## LUFTDYKTIGHETSPÅBUD

AVCC  
LYCOMING  
SAMMENDRAG  
1946 - 1970

Med hjemmel i lov om luftfart av 16. desember 1961, § 47, 2. ledd og § 214, fgl. res. av 8. desember 1961, litt. K og Luftferdselsdepartementets brev datert 22. mars 1964, fastsetter Luftfartsdirektoratet følgende forskrift:

Figure 1. Propeller Governor Line Support

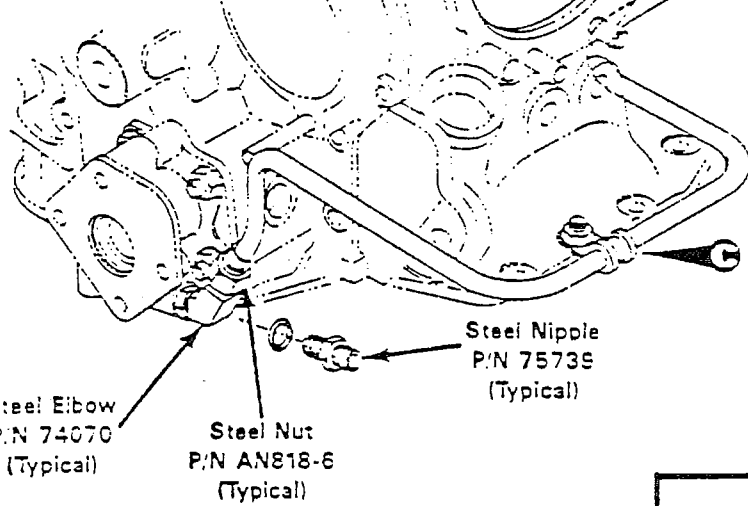
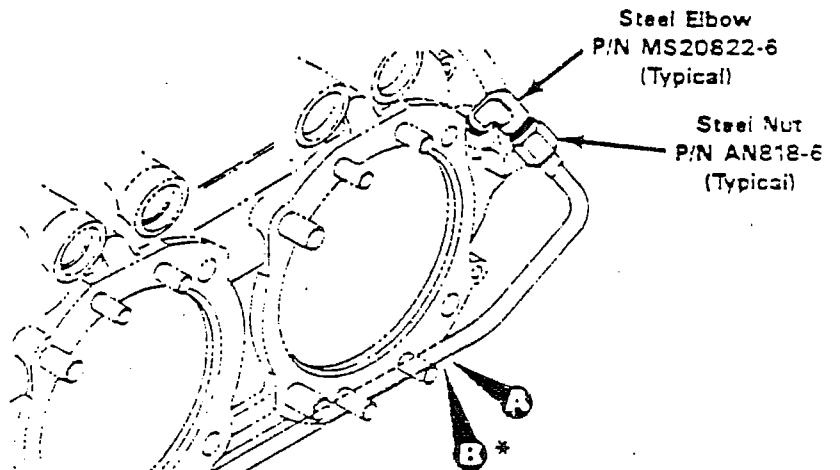
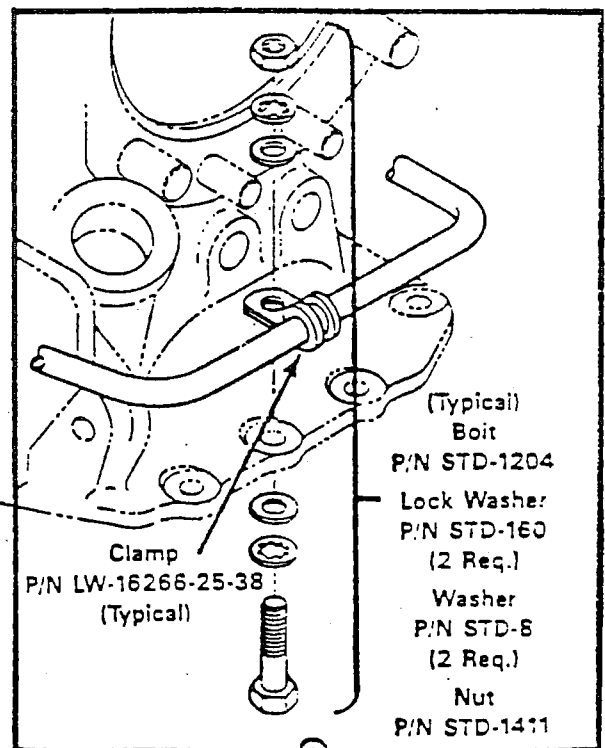
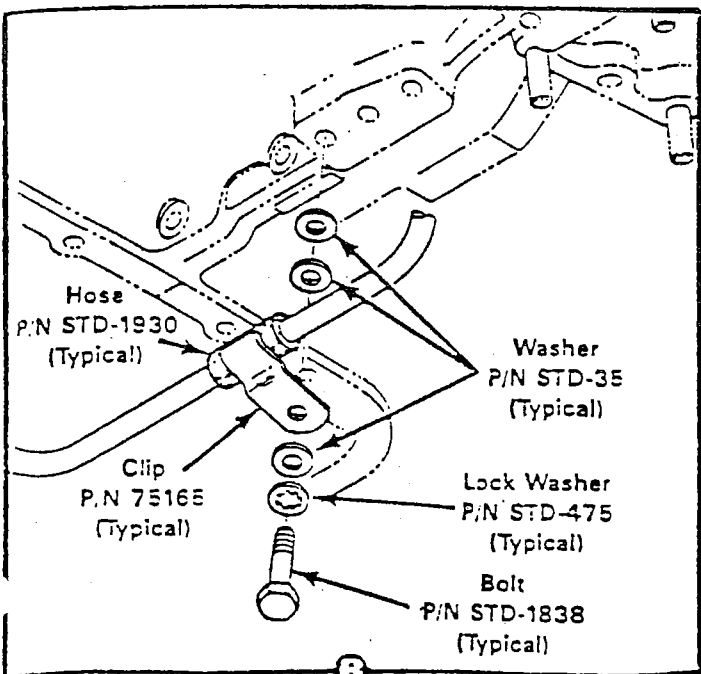
Textron Lycoming has approved the usage of the Piper Aircraft Corp. air conditioning bracket as a support of the propeller governor line. The split Hose P/N STD-1930 must still be used along with the bracket and hardware supplied by the airframe manufacturer. It is essential that the attaching bracket is properly installed so that it firmly supports the split hose covered governor line to the crankcase.

\* Most older standard cylinder flange engines differ at this crankcase attaching point of the propeller governor line as opposed to the wide cylinder flange attachment shown in this illustration. Standard cylinder flange engines use an Adel clamp which attaches to the bottom crankcase perimeter bolt directly aft of the generator bracket. Fittings for standard cylinder flange line may be -5 (5/16") instead of -6 (3/8"). Also, some earlier model propeller governor drives used 1/4" NPT fittings in the prop. governor adapter. If any of these fittings are found, replace with equivalent AN or MS steel fittings.

Figure 1. Routing, Fittings and Clamping Detail

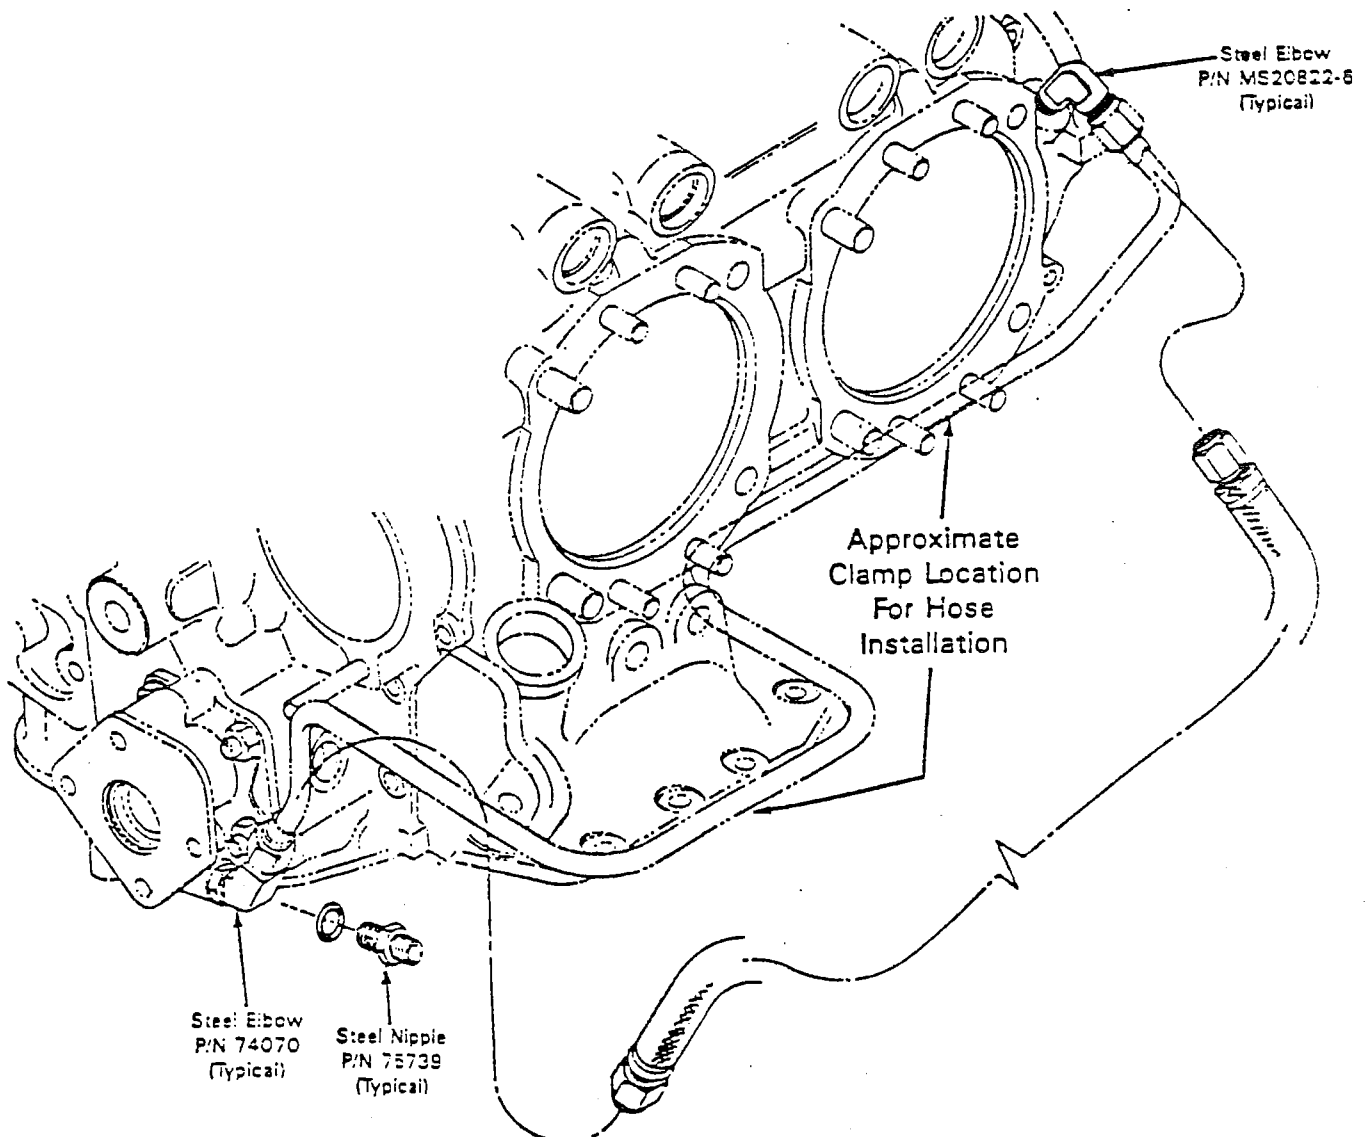
IT IS MANDATORY THAT THIS FLEXIBLE HOSE BE REPLACED AT EACH OVERHAUL.

When this engine modification is accomplished, Textron Lycoming recommends that a copy of the approved FAA Form 337 — plus the proper logbook entry become a permanent part of the aircraft records.
